From: Michael Mahoney
Sent: Monday, May 8, 2023 4:34 PM
To: Davis, J.Michael
Cc: Mack, Jarrett; Natreon Jordan; Gregg Ellis
Subject: Audit Plan - St. Lucie ITS Conversion LAR - Setpoints (EPID L-2022-LLI-0000)
Attachments: St. Lucie - Audit Plan - ITS Setpoints.docx

REGULATORY AUDIT PLAN
REGARDING LICENSE AMENDMENT REQUEST FOR
CONVERSION TO IMPROVED STANDARD TECHNICAL SPECIFICATIONS
FLORIDA POWER AND LIGHT COMPANY
SAINT LUCIE PLANT, UNITS 1 AND 2
DOCKET NOS. 50-335 AND 50-389
EPID NO. L-2021-LLI-0000

From Example 1 in IC-3.17 Page A24

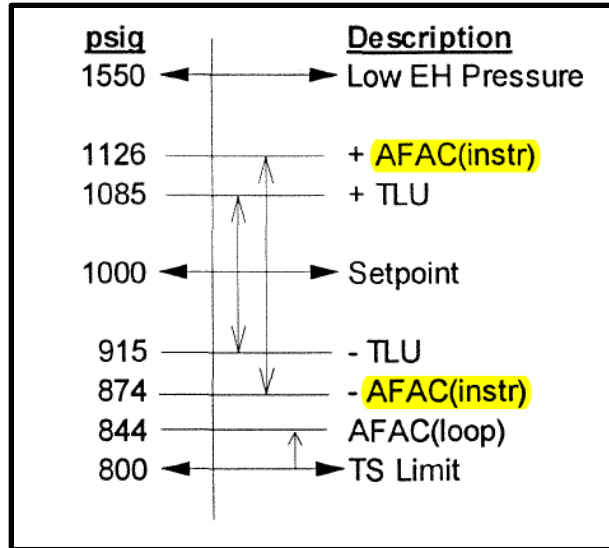
In Example 1 of Appendix A, Unit 1 PS-22-120, (Page A24) of IC-3.17 the example diagram depicts the “ \pm AFAC(instr)” value exceeding the TLU. However, in Section VIII. Setpoint Determination Part D, it describes the “Total Loop Uncertainty (TLU) Equation” and in Part E, “Setpoint Value Equations for RPS & ESFAS Functions” it describes the setpoint (SP) equal to the analytical limit (AL) minus the TLU.

$$SP = AL - TLU$$

In Example 1 of Appendix A of IC-3.17 is it acceptable for the AFAC value to exceed the TLU, based on a comparison of the diagram and the equation above? If so, how does this address TSTF-493 criteria?
